From: Manoj Nathoo (AT)
Sent: Wednesday, 30 April 2025 9:37 am
To: Siobhan O'Donovan (AT)
Subject: FW: Cross St/East St/Canada IFC

From: Putri Kusumawardhani (AT) <Putri.Kusumawardhani@at.govt.nz>
Sent: Wednesday, 12 March 2025 12:41 pm
To: Manoj Nathoo (AT) <Manoj.Nathoo@at.govt.nz>; Sophia Wang (AT) <Sophia.Wang@at.govt.nz>; Vaughn Scott (AT) <Vaughn.Scott@at.govt.nz>
Cc: Suresh Patel (AT) <Suresh.Patel@at.govt.nz>; Road Safety Engineering (AT) <RoadSafetyEngineering@at.govt.nz>; Mathew Rudez (AT) <Mathew.Rudez@at.govt.nz>; Jason Budd (AT) <Jason.Budd@at.govt.nz>; Ian Kingston (AT) <Ian.Kingston@at.govt.nz>
Subject: RE: Cross St/East St/Canada IFC

Thanks Putri and Vaughn for your valuable inputs on the design changes on Cross St. I summarised the comments/actions as listed below:

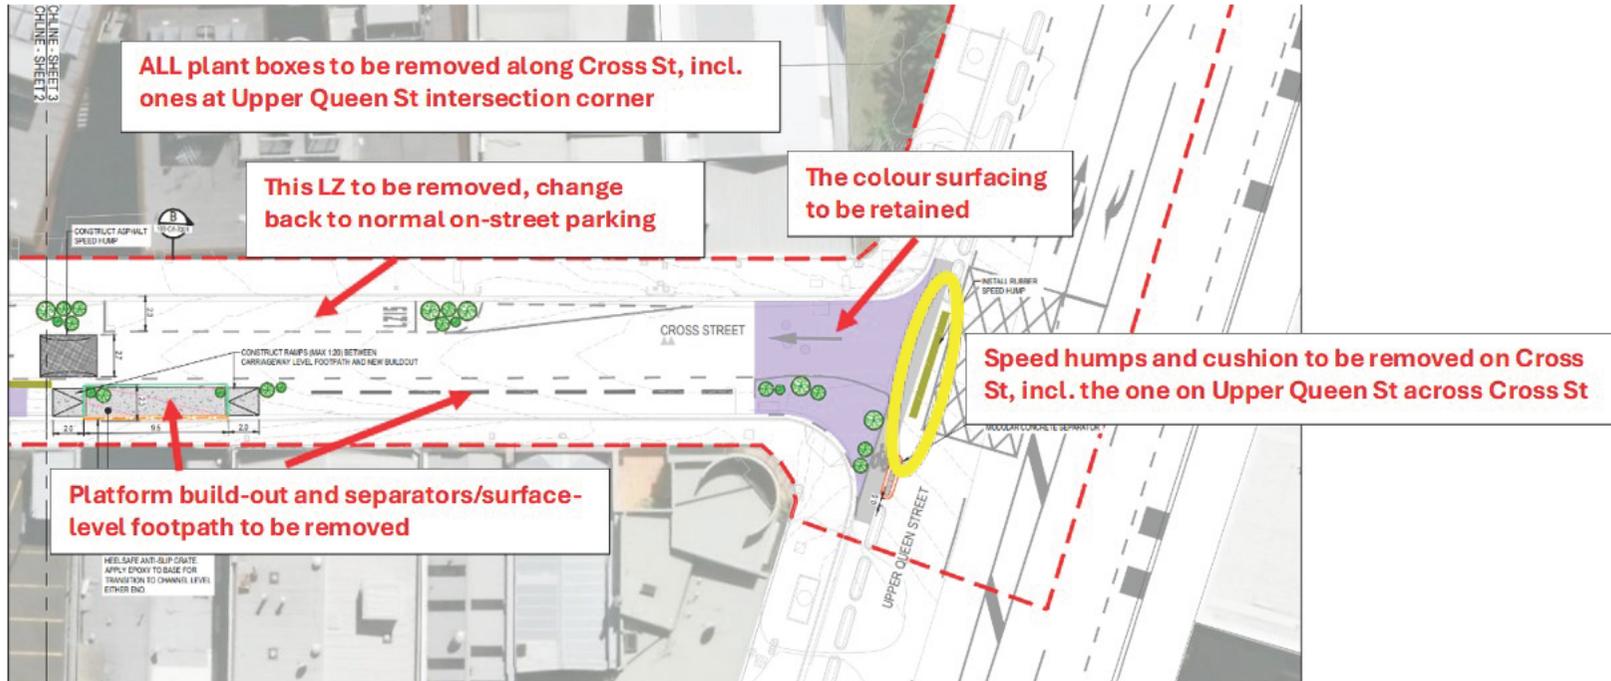
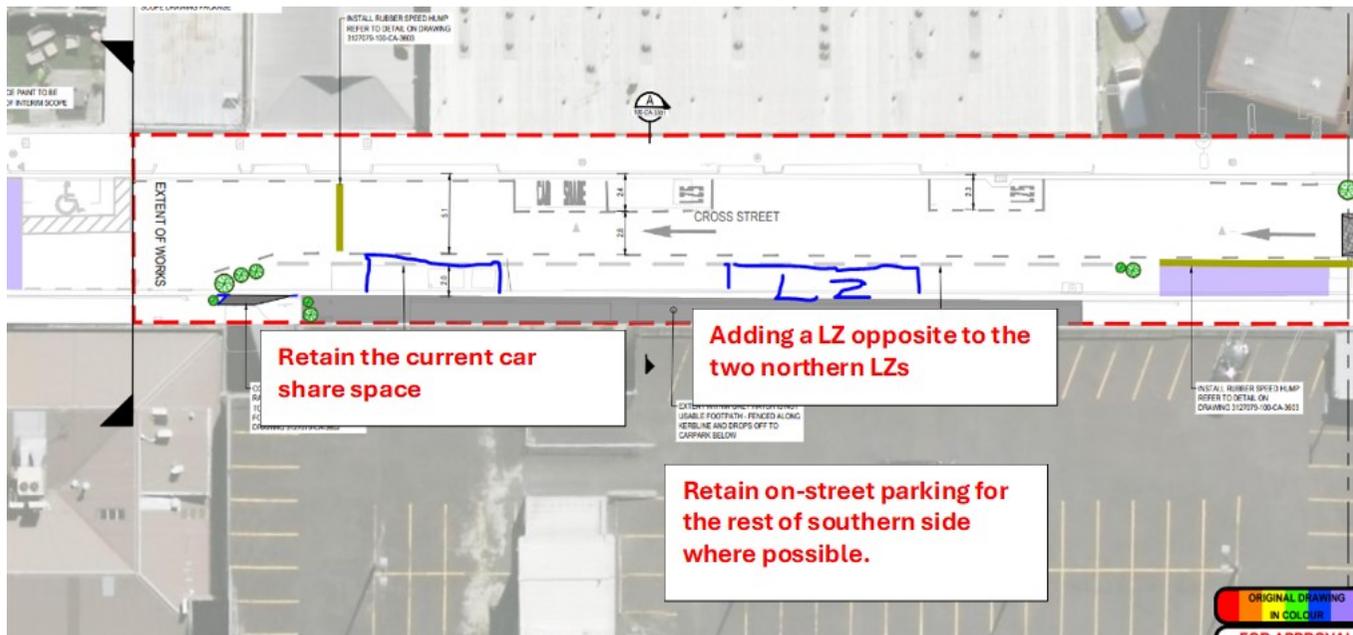
Another item the project team wish to draw your attention is that the speed hump across Cross Street at Upper Queen St intersection is to be removed (yellow circled in the snip below) along with other vertical devices along Cross Street, which was strongly suggested by Murray Burt due to the unpleasant experience and damage it may cause to the turning traffic, especially the delivery trucks. You can refer to pg. 6-7 in the Engineering Package attached for the original Cross St design, and the snips below showing the changes that were recommended and endorsed by Murray. The project team would like to check with you as the key SMEs to this particular item, if any of you have any major concern on the changes. If yes, please kindly provide us a strong justification for keeping any original proposal, for our further engagement with Murray Burt and project PCG.
